Memorandum

From: South Orange Design Review Board

Subject: Application #268- The Learning Center 109 & 115 South Orange Ave. West

Figure 1: Original facade

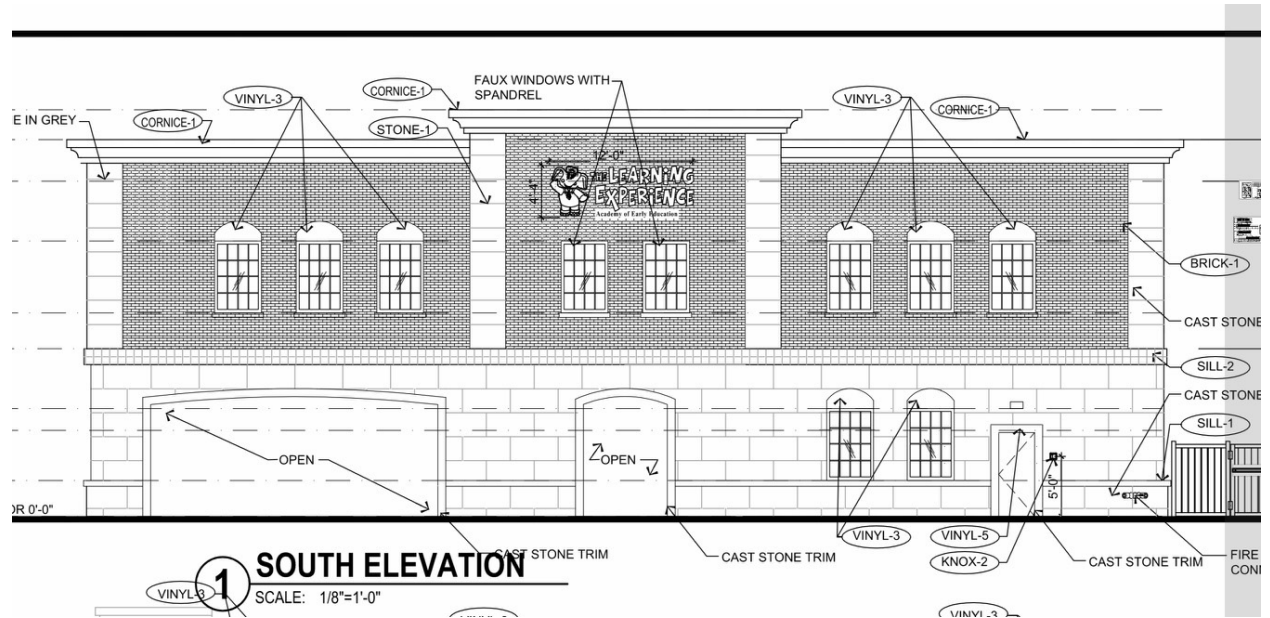
With any application we always prefer the ground floor to be active space with window interest. Driveway entrances on the front façade make this challenging. We asked that the design of the façade be updated to help the building feel more active on the ground floor and a smaller driveway entrance. Larger windows on the ground floor and lighting are key ways to make the first floor more active. The revised drawings are much improved with larger windows and lights.
